*Florence County Government*  
Procurement Department

**ADDENDUM NO. 2- JOHNSONVILLE BALL FIELDS (BID NO. 34-14/15)**

**Answers to Questions from the Pre-Bid Meeting held on 6/25/15. The answers are in BOLD RED.**

TYPICAL 225' FIELD (DIXIE YOUTH  
LEAGUE)

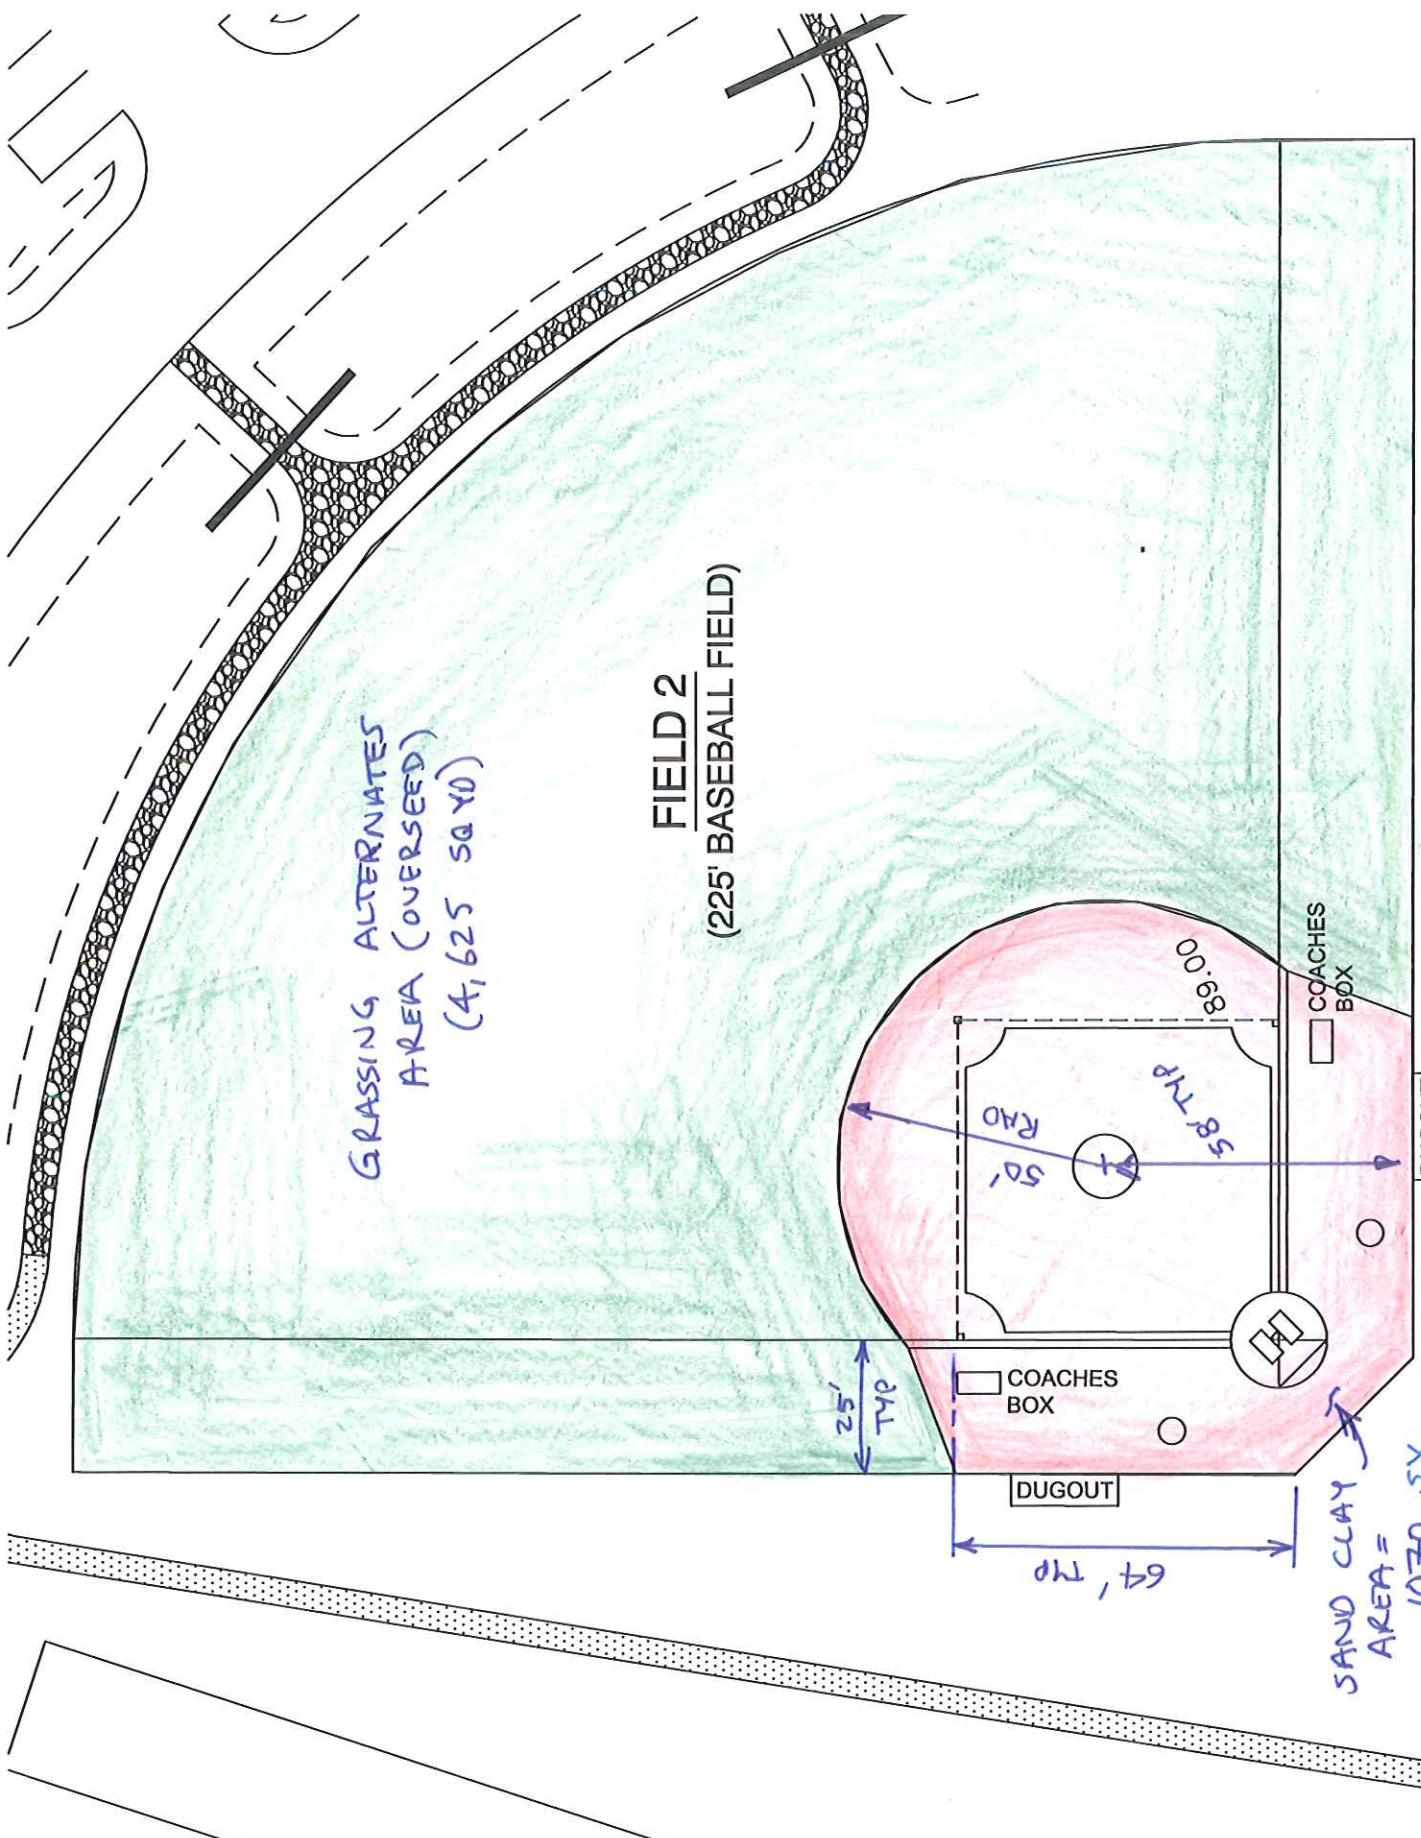
15. Please update the drawing with a sheet outlining the sand-clay limits that the County will be providing. **Please see attached sketch. The entire infield will be sand clay (no grass diamond in the center). Leave 4" for the sand clay thickness; this corresponds with the 4" of topsoil in the outfield to make grading easier. As for complete dimensions, see the web site [www.youth.dixie.org](http://www.youth.dixie.org) for the 225' field and [www.baseball.dixie.org](http://www.baseball.dixie.org) for the 325' field.**

325' FIELD (BRONCO LEAGUE)

GRASSING ALTERNATES  
AREA (OVERSEED)  
(4,625 SQ YD)

SAND CLAY  
AREA =  
1070 SY  
ASSUME 4" OF SAND CLAY
